## PLANNING AND ZONING BOARD STAFF REPORT

### The Tropics

Meeting	File No.	Application Type
July 15, 2024	2024-030-SPM-SPR-LV4 & 2024-031-USE-PZB	Level 4 Site Plan; Conditional Use, Free Standing Multiple-Family Housing
Property Owner	Authorized Agent	
Federal 2400 LLC & 2410 Federal LLC	Jeffrey Costello

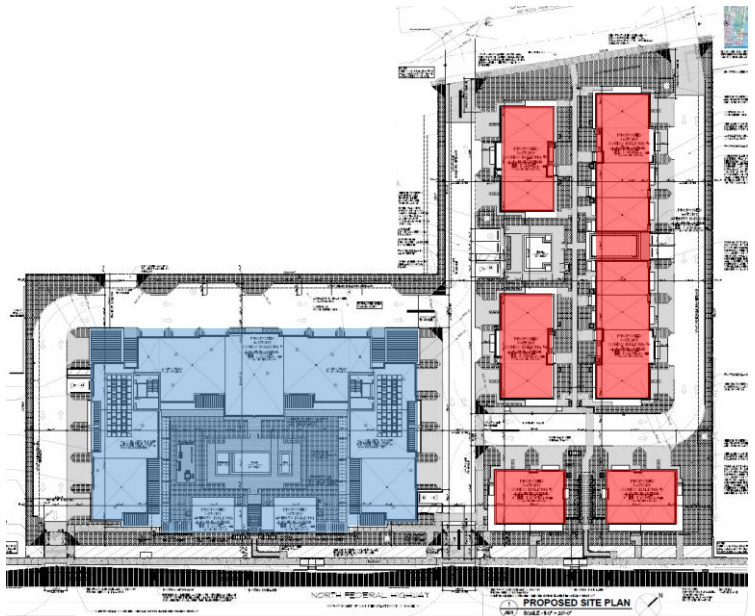
There are two ground floor amenity areas, one located amongst the townhouse-type units and one within the four-story building. The larger four-story building (in blue, at right) includes designated garages and private pool cabanas on the ground floor, while the residential units are located on the second through fourth floors. The three-story townhouses (in red, at right) are dispersed amongst five structures, with four units fronting North Federal Highway and the remaining 14 units separated into two rows of six and eight units where the units front a pedestrian pathway that divides the two rows. A pool and gym / fitness building are provided for the townhouse units. While some of the units are proposed in a townhouse typology, it is important to note that the entirety of the project will be structured as a condominium and there are no proposed fee-simple lots.

1. **LDR Section 4.6.9(D)(3)(c)1.:** Relief from the required 50-foot stacking distance from Federal Highway and Dixie Highway to allow a stacking distance of 23'8" from Federal Highway and 24'6" and 35'20" from Dixie Highway;
2. **LDR Section 4.6.9(D)(6)(d):** Relief from the required drive aisle width of 24 feet to allow 22 feet;
3. **LDR Section 4.3.3(O)(4)(b):** Relief from the 200-foot maximum length of a townhouse building to allow a length of 222'8"
